## DEVELOPMENT APPLICATION ASSESSMENT REPORT

<b>Application Number:</b>	DA2025/0150
----------------------------	-------------

<b>Responsible Officer:</b>	Anaiis Sarkissian
<b>Land to be developed (Address):</b>	Lot 19 DP 8698, 77 Central Road AVALON BEACH NSW 2107
<b>Proposed Development:</b>	Demolition works and construction of a dwelling house including swimming pool
<b>Zoning:</b>	R2 Low Density Residential
<b>Development Permissible:</b>	Yes
<b>Existing Use Rights:</b>	No
<b>Consent Authority:</b>	Northern Beaches Council
<b>Land and Environment Court Action:</b>	No
<b>Applicant:</b>	Joel Warwick Schuberg

**Figure 1: Original pool location**

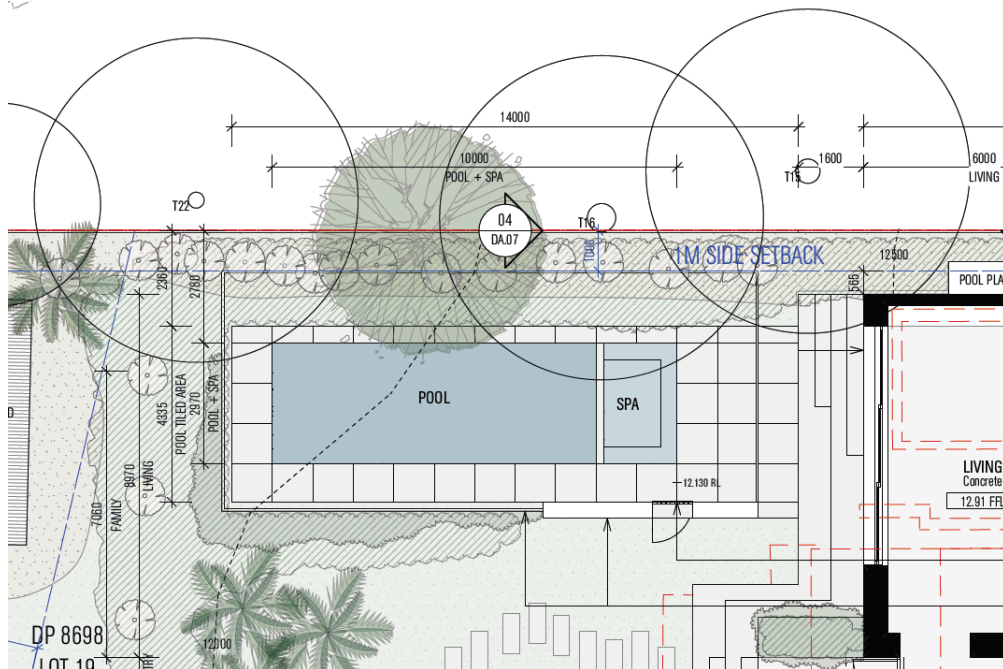
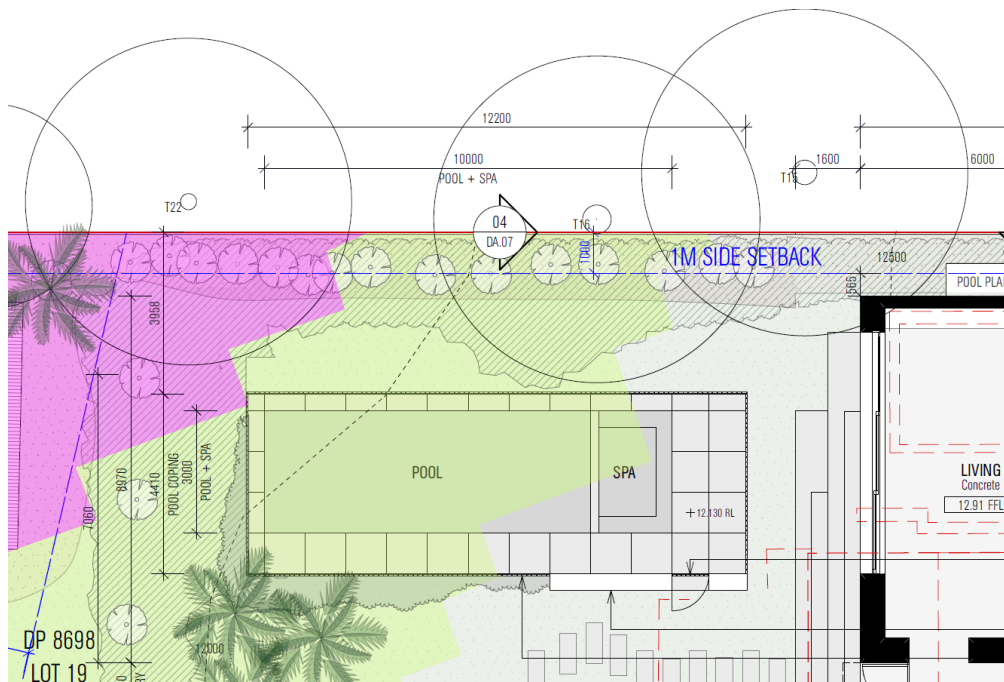
*The submission raised concerns over the impact of the proposed inground swimming pool being sited 2.78m from the western side boundary on the neighbouring trees, particularly Tree 16. The submission notes that the Arboricultural Impact Assessment identifies the incursion of the excavation for the pool into the TPZ of Tree 16 at 26%, but that the pool will result in a much greater incursion into the TPZ and also an incursion into the SRZ, which could cause significant damage to the root system of the tree.*

The amended proposal shifts the swimming pool further east such that it is now sited 4.4m from the western boundary (refer Figures 1 and 2). An updated Arboricultural Impact Assessment was also submitted on 3 April 2025, which states that the encroachment into the TPZ of Tree 16 is now 19%, with no encroachment of the SRZ (refer Figure 3). The Arborist's report states that the stability of this tree will be maintained and no root mapping is required. Trees 14 and 15 have 14% and 12% encroachments into their TPZs, respectively, while there is nil impact to Tree 22. The Arborist recommends the installation of tree protection measures around these trees (refer Figure 4). The recommendations of the Arborist's report have been included within the conditions of this consent.

**Figure 6: Eastern elevation at ground level**

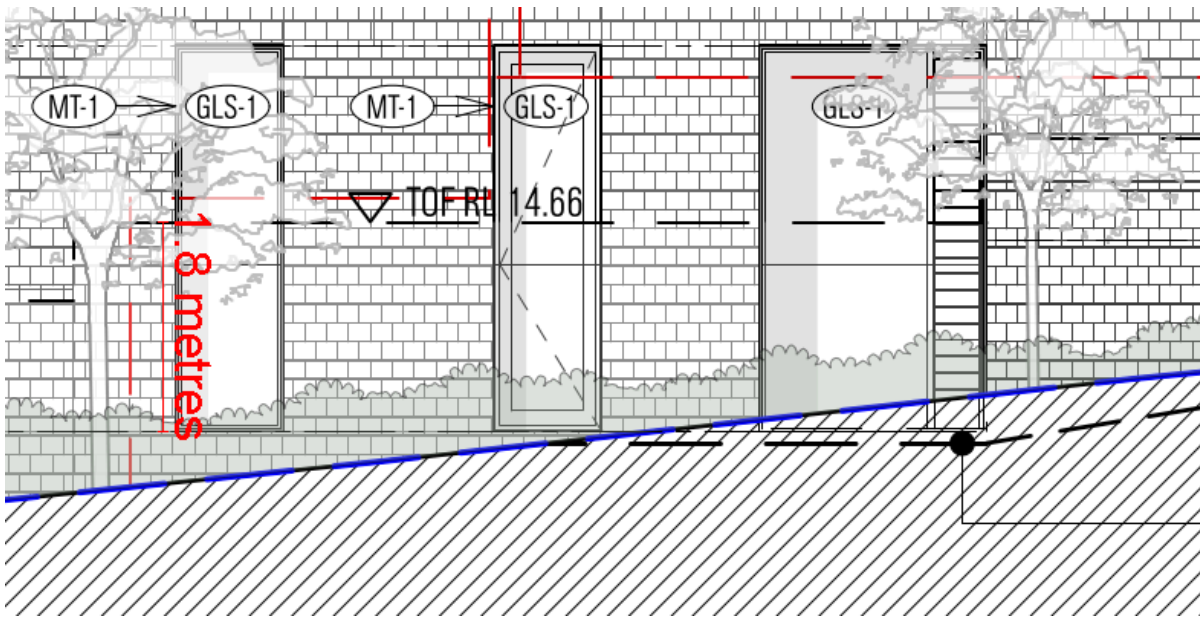
The eastern building line is located 6.3m from the western elevation and windows of the adjoining property to the east at 75 Central Road. The windows at the ground floor at the eastern elevation are screened by the boundary fence, as shown dashed black at Figure 6 below, the top of which sits at a height of 1.8m above the finished ground floor level.

In terms of the windows to the eastern elevation to the ground floor, these are all to bedrooms, an ensuite and a study. It is noted that these are all low use rooms, with the exception of the study, and there is dense vegetation along the common boundary, as evident in Figures 7 and 8 below. Notwithstanding, the proposed glazing is substantial and does not include any privacy mitigation measures (refer Figure 9). A condition has therefore been included within this consent, requiring all the windows on the first floor at the eastern elevation to incorporate obscure glazing up to a height of 1.6m from the finished floor level.

All windows to the first floor at the eastern elevation as shown on the approved plans are to incorporate obscure glazing up to a height of 1.65m (measured from finished first floor level).

**Figure 10: Pool plant location**

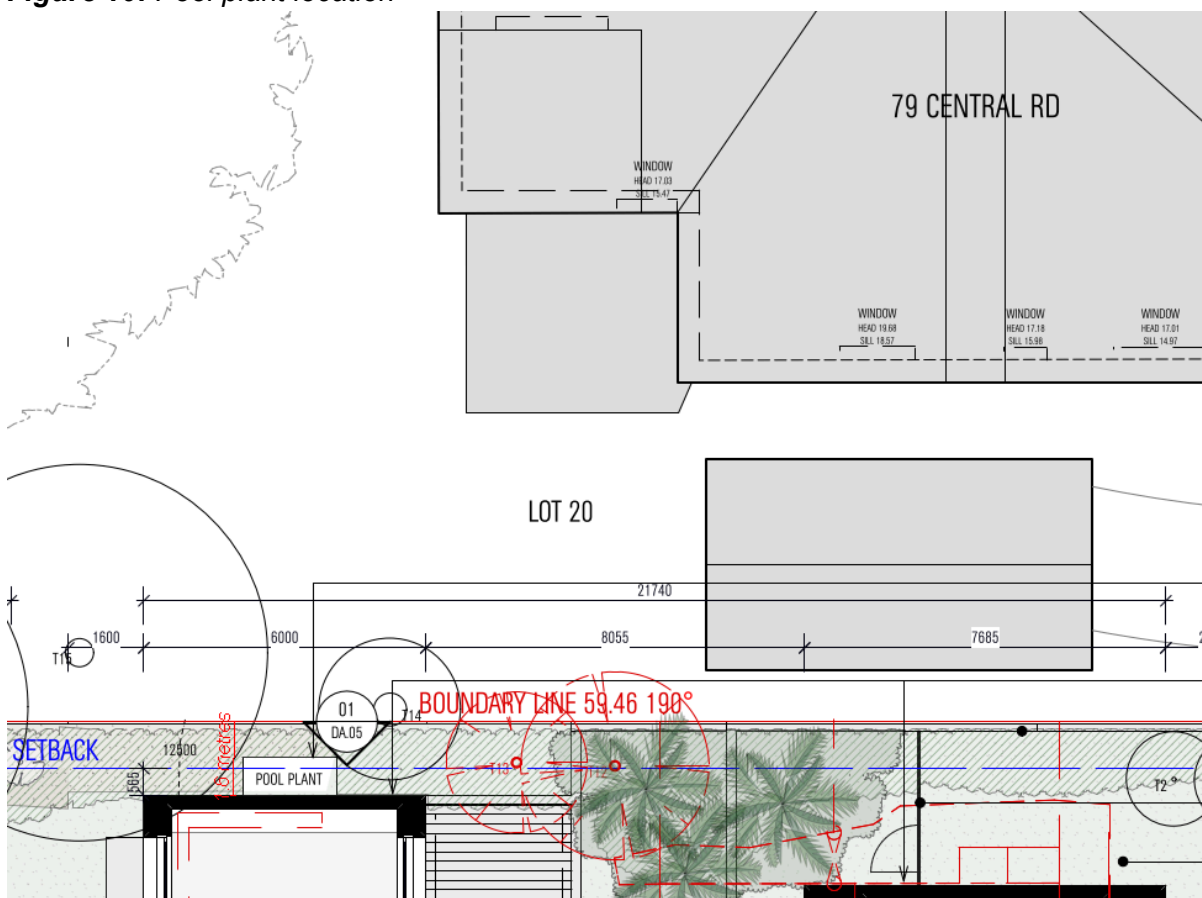
The proposed pool plant is located at the western edge of the proposed building, and is identified on the architectural plans as being within an acoustic enclosure (refer Figure 10 below). Notwithstanding, two ongoing conditions have been included within this consent requiring any pool plant to be contained within an acoustic enclosure at all times, and requiring the swimming pool / spa motor and other noise generating plant including air conditioning units to not produce noise levels that exceed 5dBA above the background noise when measured from the nearest property boundary. The location of the proposed pool plant is considered acceptable, subject to compliance with these two conditions of consent.

The proposed pool plant is to be contained within an acoustic enclosure at all times.

**Figure 11: Eastern elevation**

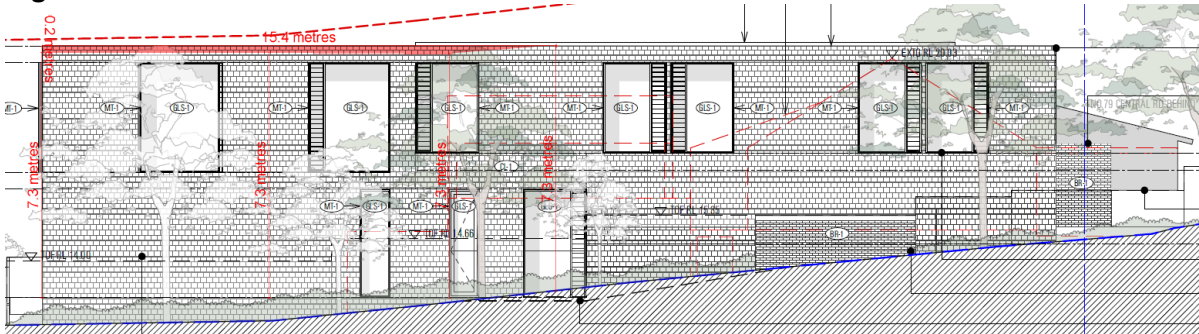
The eastern elevation presents an encroachment of between nil and 0.2m in height for a length of 15.4m, resulting in a maximum variation of 2.7% (0.2m), as shown shaded red at Figure 11 below. The portion of the building outside of the envelope is minor and does not include any glazing.
